TRI-STATE GENERATION & TRANSMISSION, INC.

FOX RUN SUBSTATION FINAL DRAINAGE REPORT

PCD FILE # PPR-22-044

October 11, 2022

DRAINAGE BASIN DELINEATION

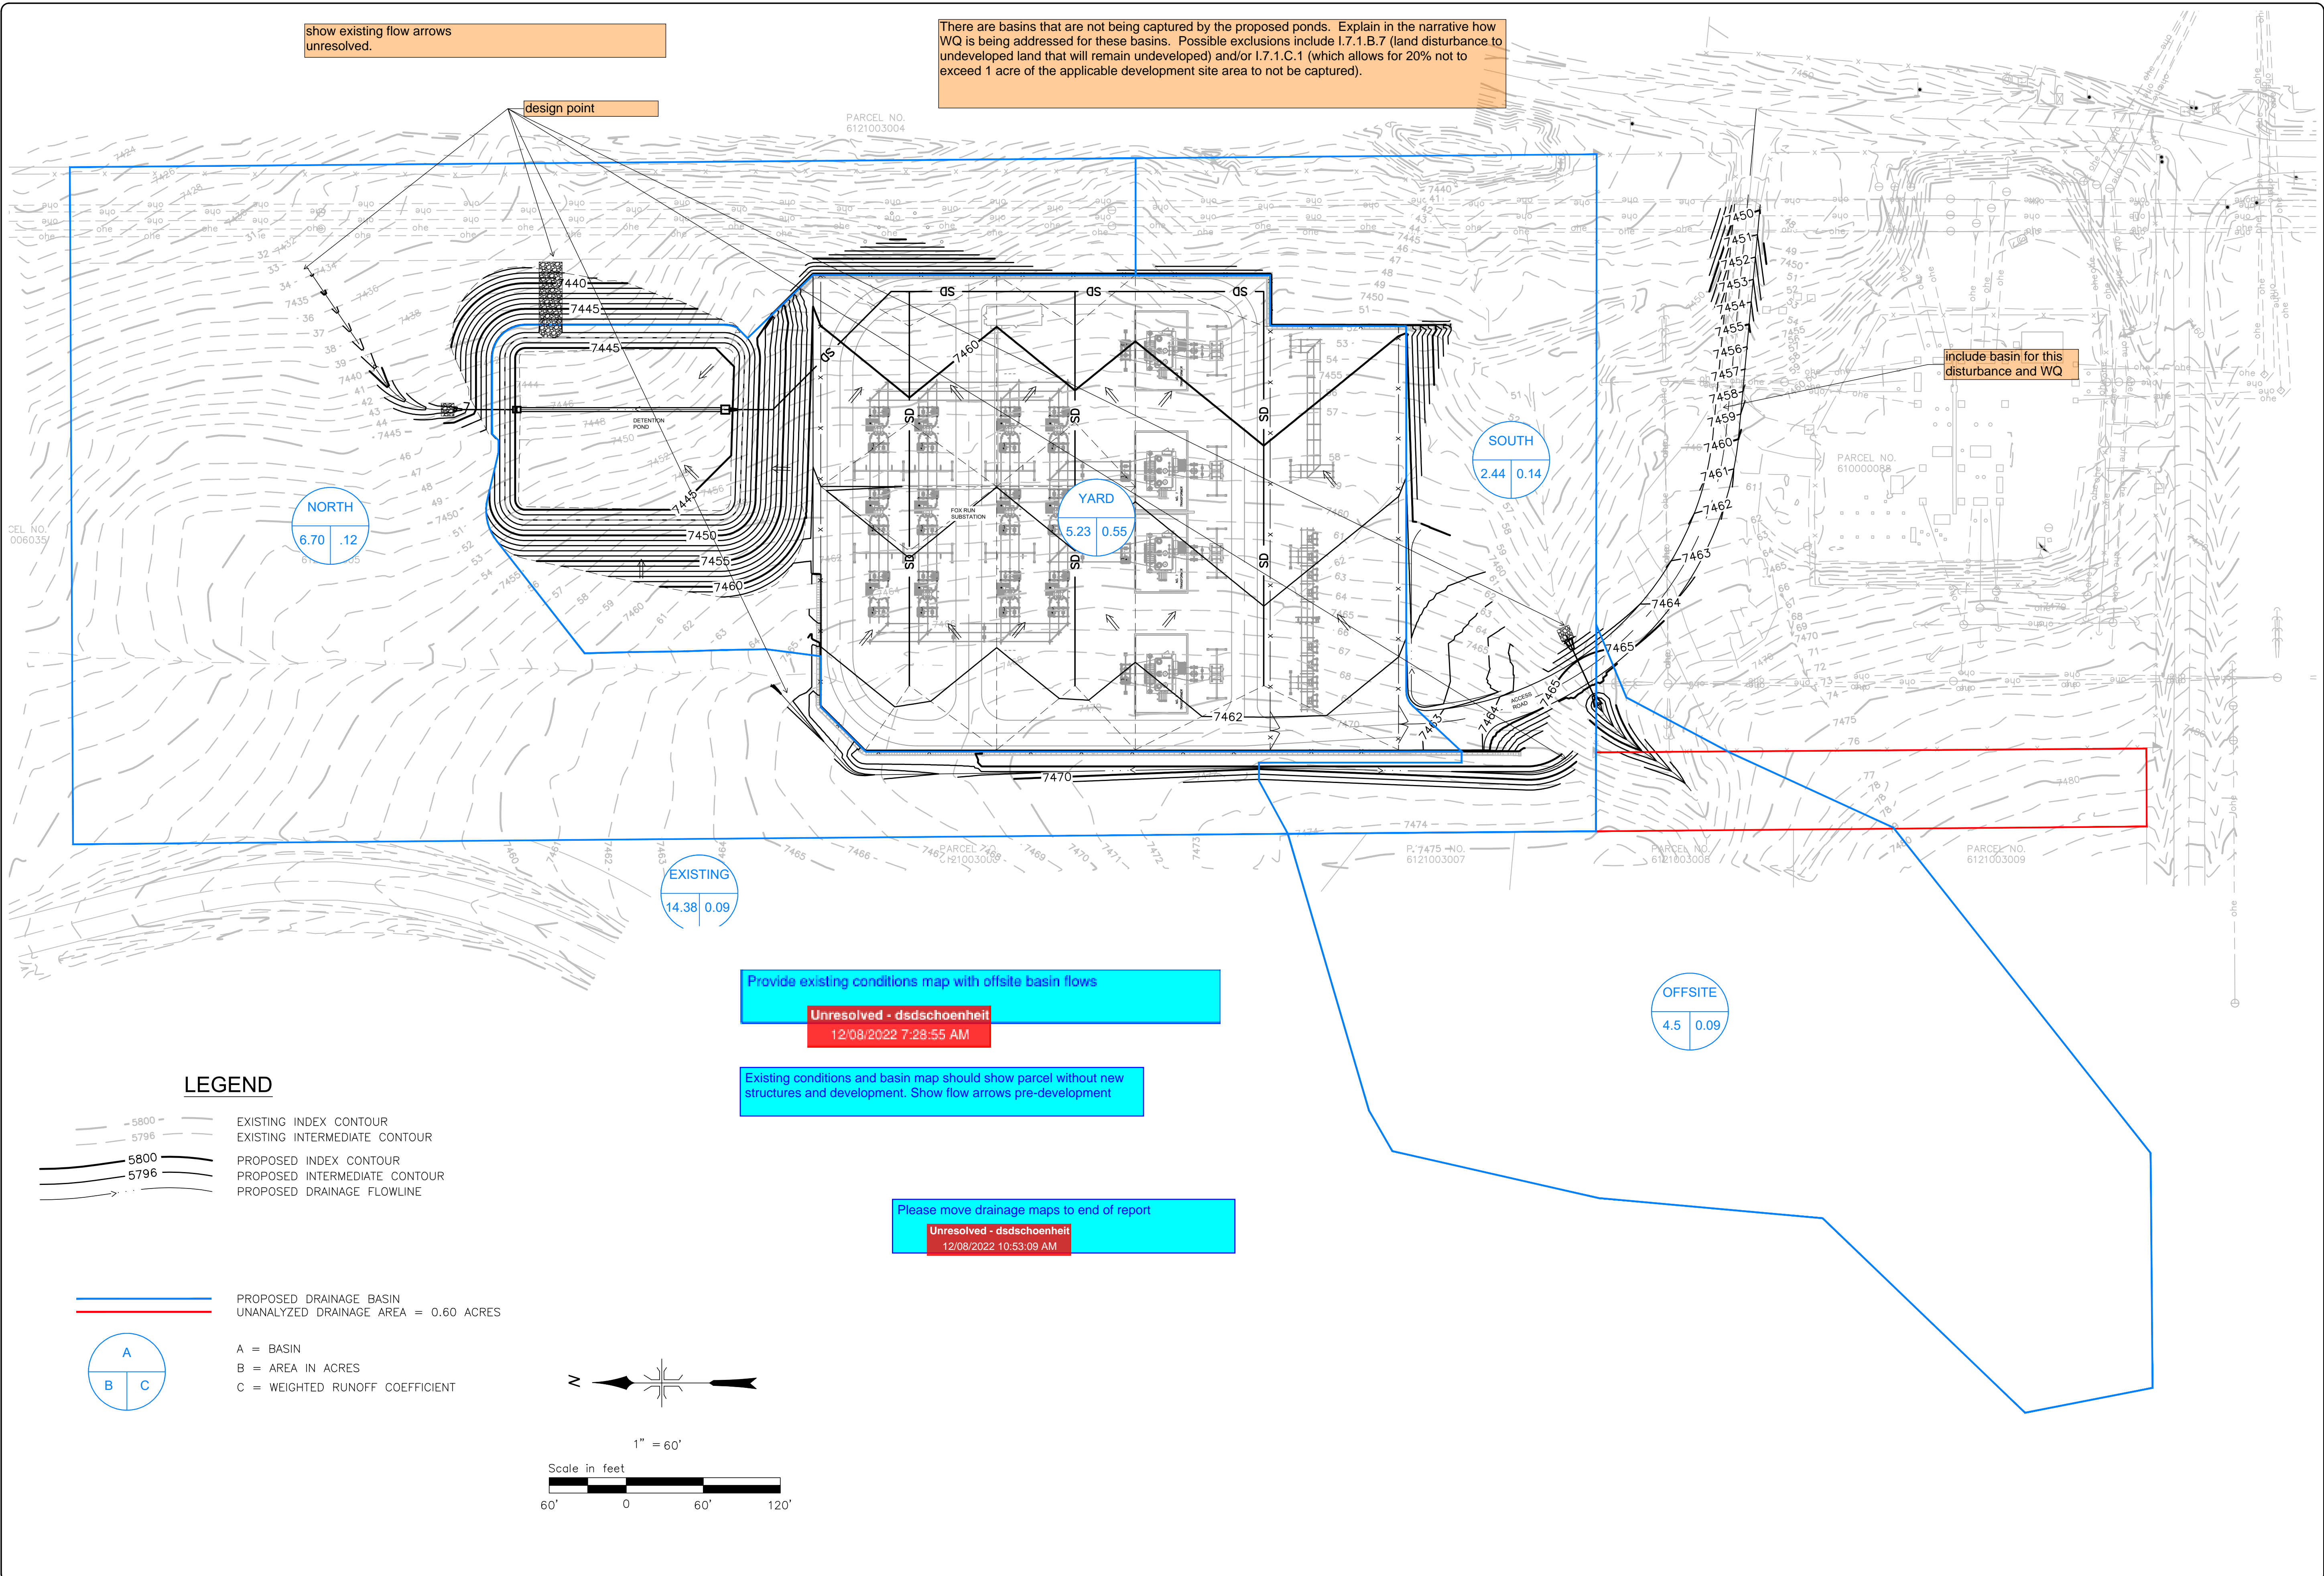
show existing flow arrows unresolved.

There are basins that are not being captured by the proposed ponds. Explain in the narrative how WQ is being addressed for these basins. Possible exclusions include I.7.1.B.7 (land disturbance to undeveloped land that will remain undeveloped) and/or I.7.1.C.1 (which allows for 20% not to exceed 1 acre of the applicable development site area to not be captured).

design point

include basin for this disturbance and WQ

Provide existing conditions map with offsite basin flows
Unresolved - ddschoenheit
12/08/2022 7:28:55 AM

Existing conditions and basin map should show parcel without new structures and development. Show flow arrows pre-development

Please move drainage maps to end of report
Unresolved - ddschoenheit
12/08/2022 10:53:09 AM

DRAINAGE MODEL SCHEMATIC

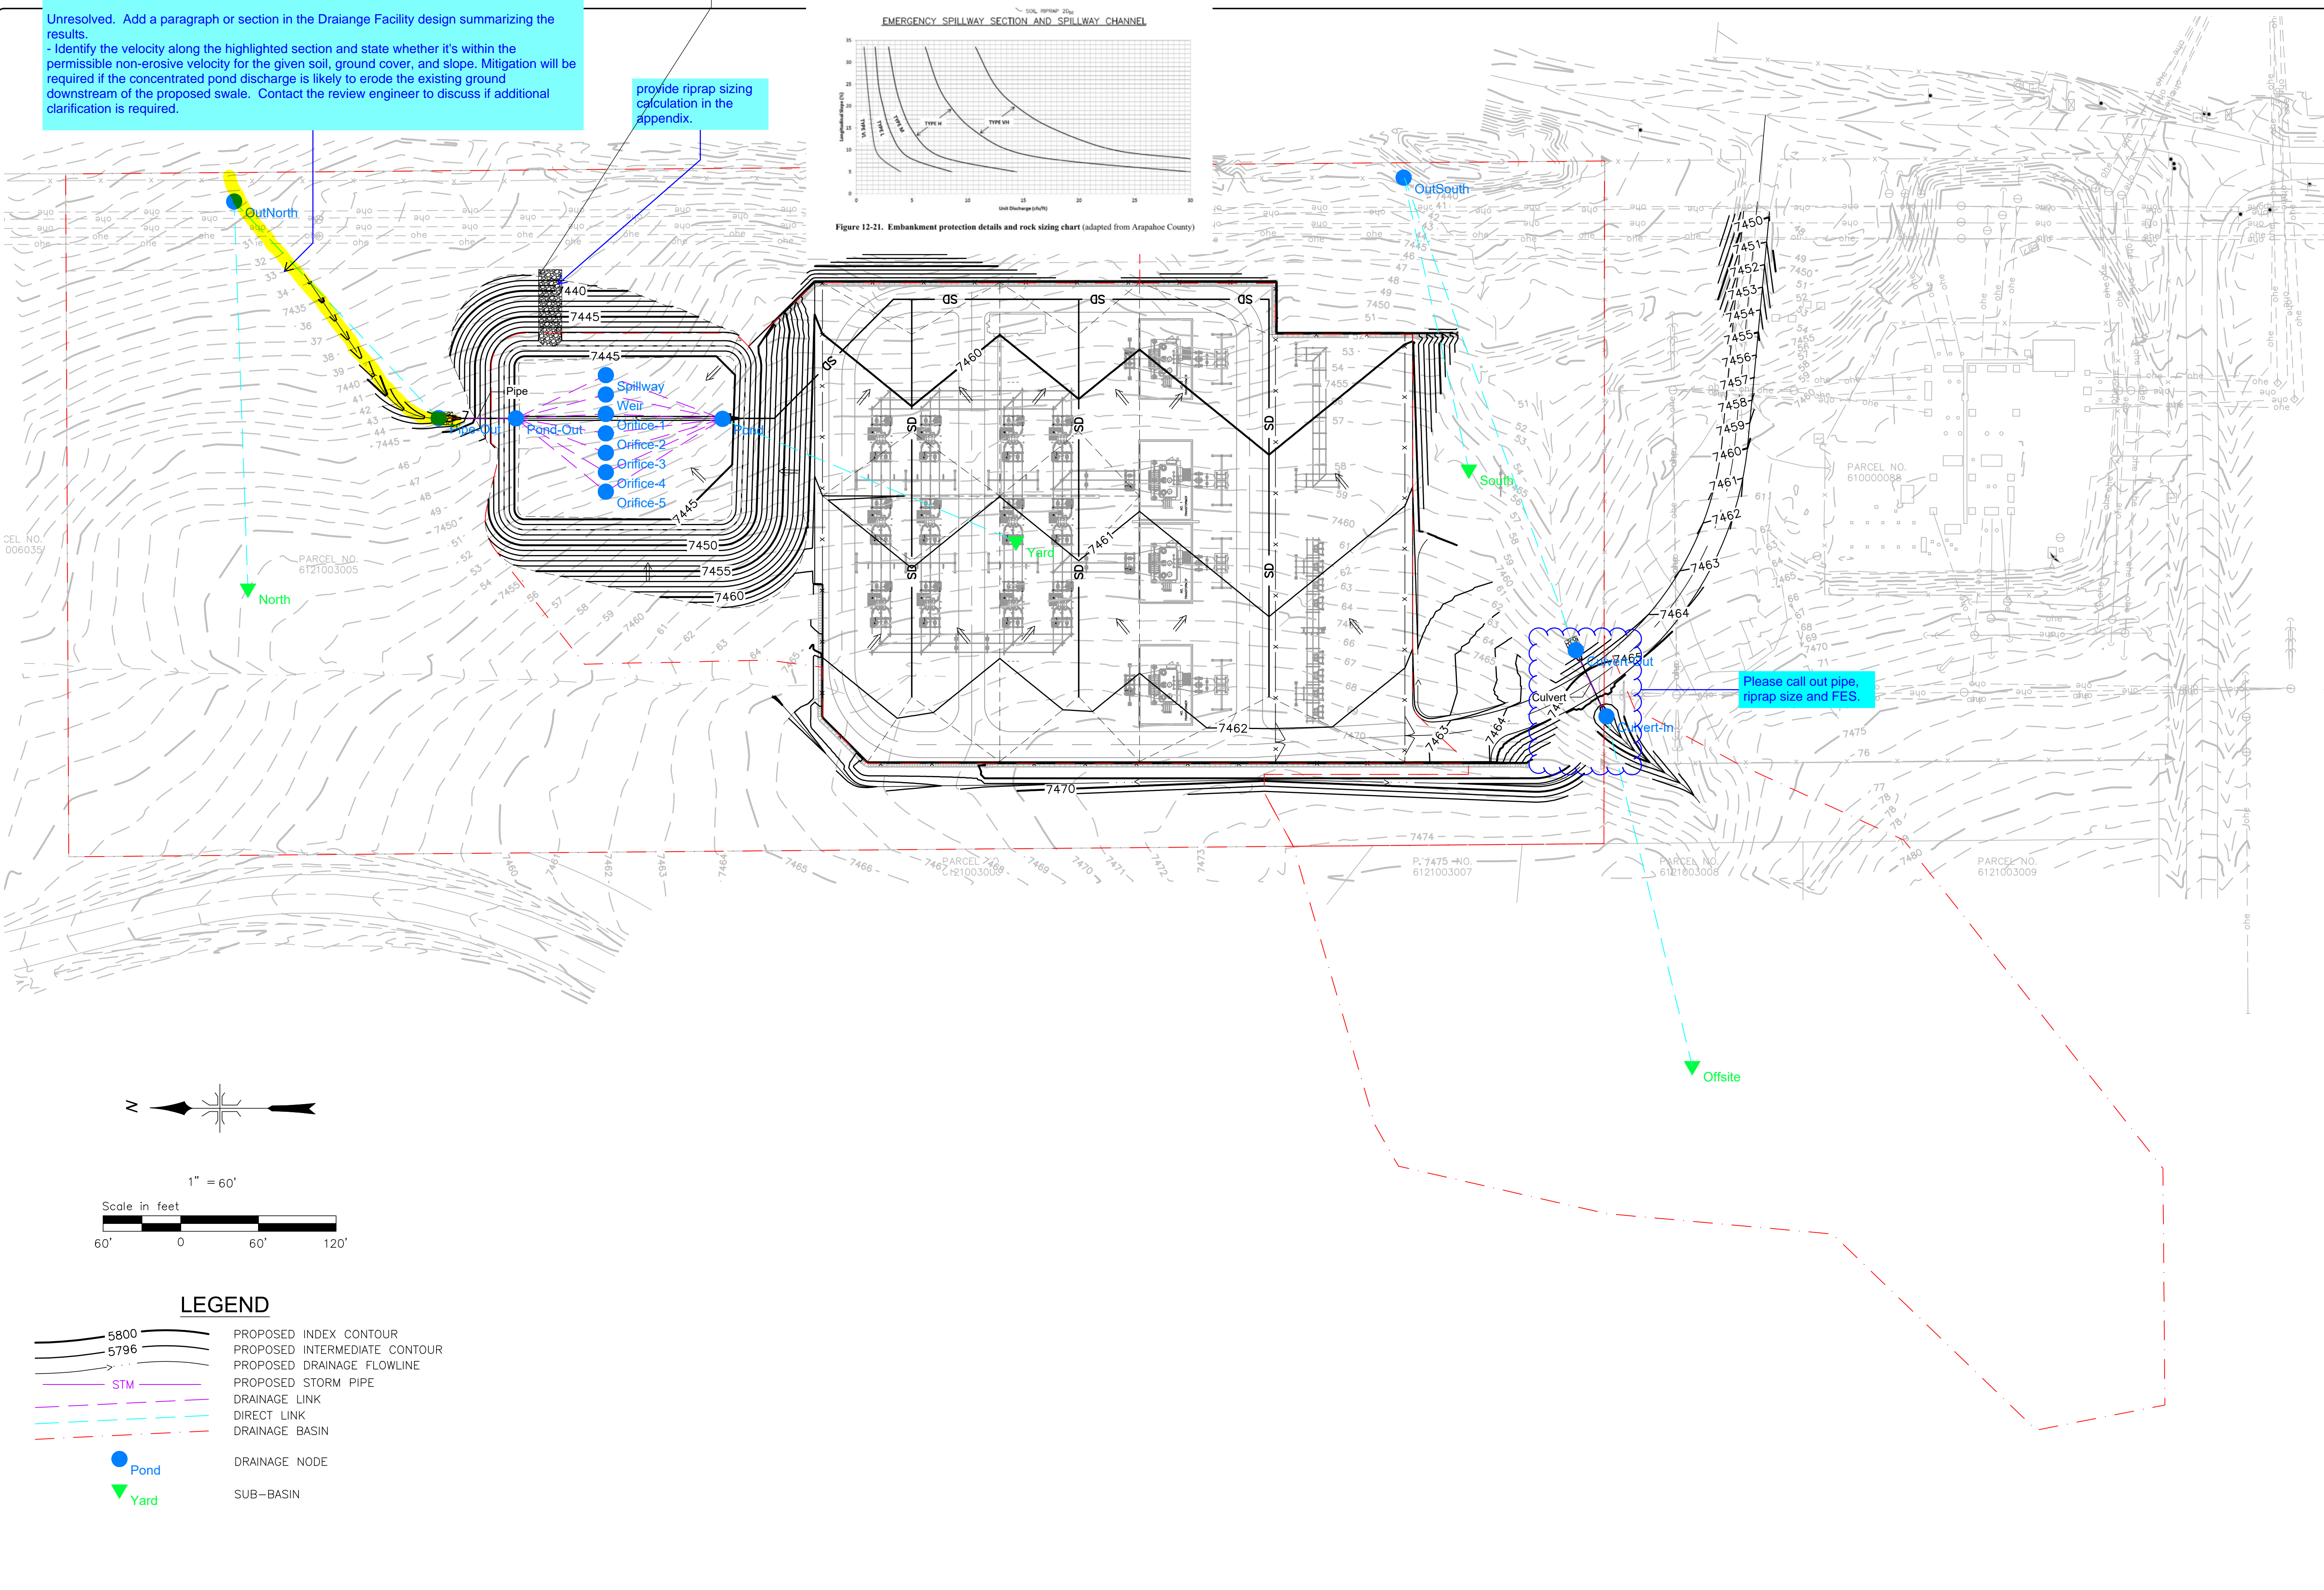
The manner of flow can be changed from sheet flow to concentrated flow. Analyze the conveyance path up to the suitable outfall as defined in ECM 3.2.4. The conveyance path must be hydraulically adequate/stable.

Unresolved. Add a paragraph or section in the Drainage Facility design summarizing the results.
 - Identify the velocity along the highlighted section and state whether it's within the permissible non-erosive velocity for the given soil, ground cover, and slope. Mitigation will be required if the concentrated pond discharge is likely to erode the existing ground downstream of the proposed swale. Contact the review engineer to discuss if additional clarification is required.

Determine if this a suitable outfall. Where will the overflow be directed?

provide riprap sizing calculation in the appendix.

DETENTION BASIN OUTLET STRUCTURE DESIGN

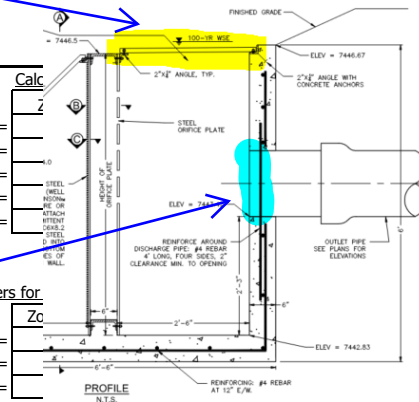
Change Zone 2 to Orifice Plate

Update Zone 3 to Weir & pipe (w/ Restrictor Plate)

Height needs to match the outlet height from the micropool to the top of grate.

Provide input to model the top of the outlet structure.

provide input to model the outlet pipe

change side slopes to "4" per plans
